# AVALON DUPLEX

93 CENTRAL ROAD, AVALON NSW 2107

# FOR COMPLYING DEVELOPMENT

C	FOR CDC APPROVAL	22/2/2024
B	CONSULTANT COORDINATION	9/10/2023
A	FOR COMPLYING DEVELOPMENT	31/8/2023
P1	FOR CONSULTANT COORDINATION	22/8/2023
REV	STATUS	DATE

DRAWING TITLE: **ELEVATIONS (SIDES)**

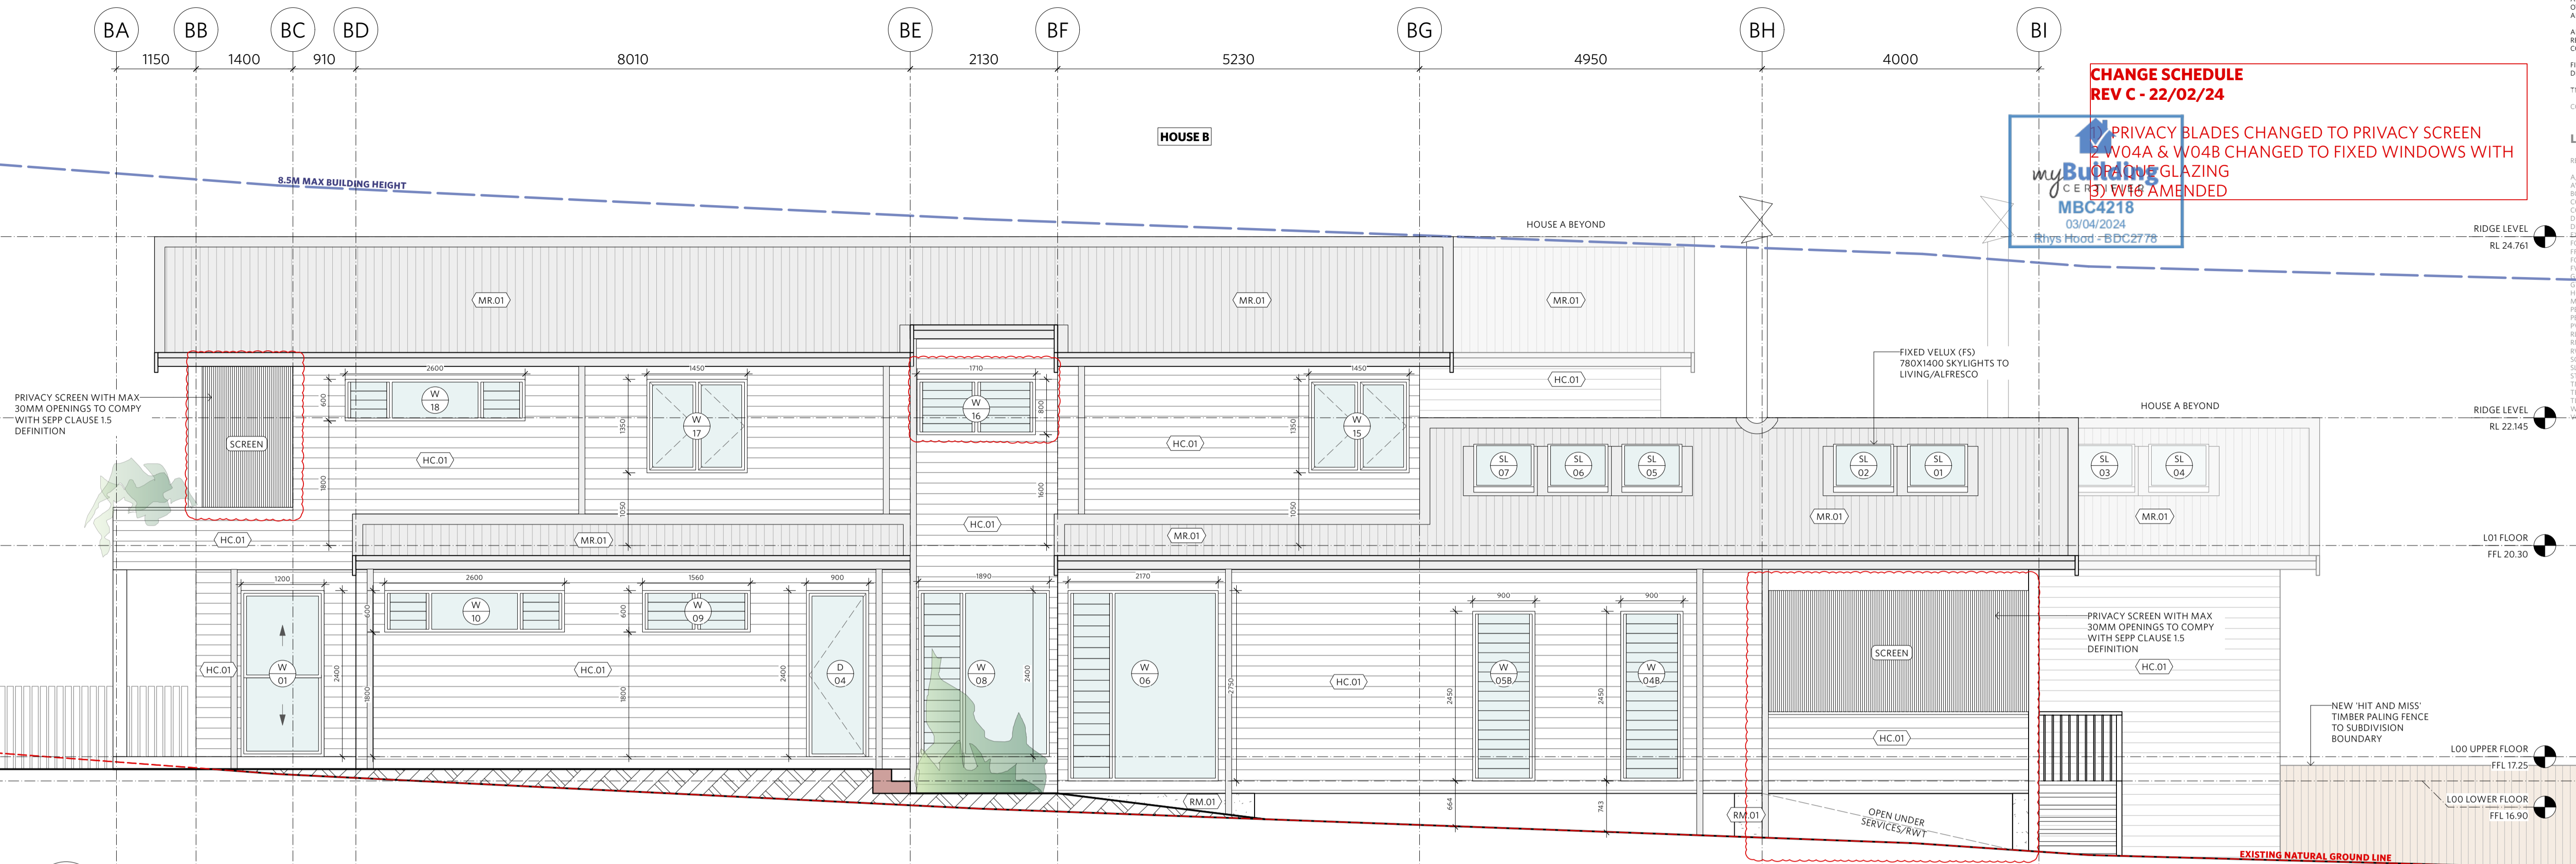
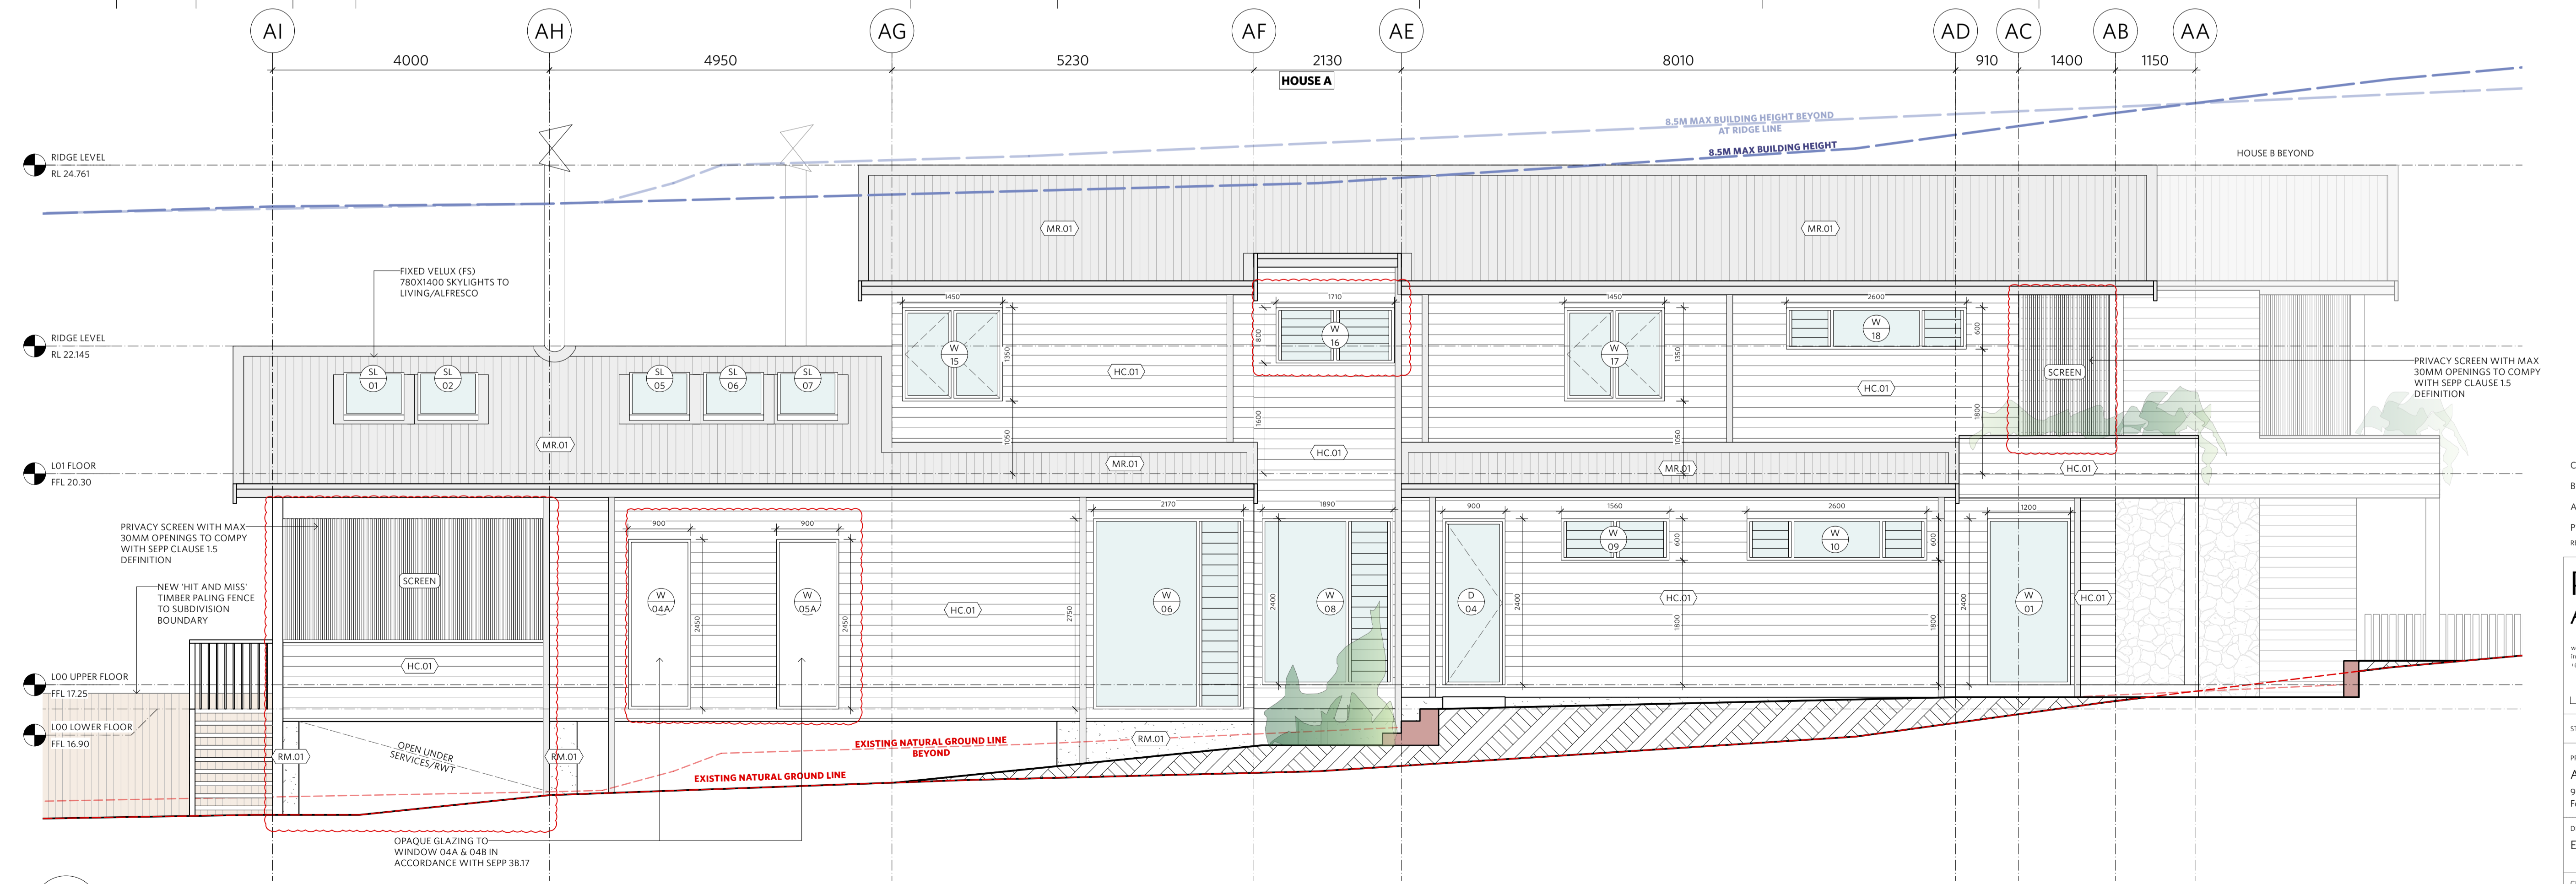
PRIVACY BLADES CHANGED TO PRIVACY SCREEN  
 W04A & W04B CHANGED TO FIXED WINDOWS WITH  
 W04A AMENDED  
 W04B AMENDED
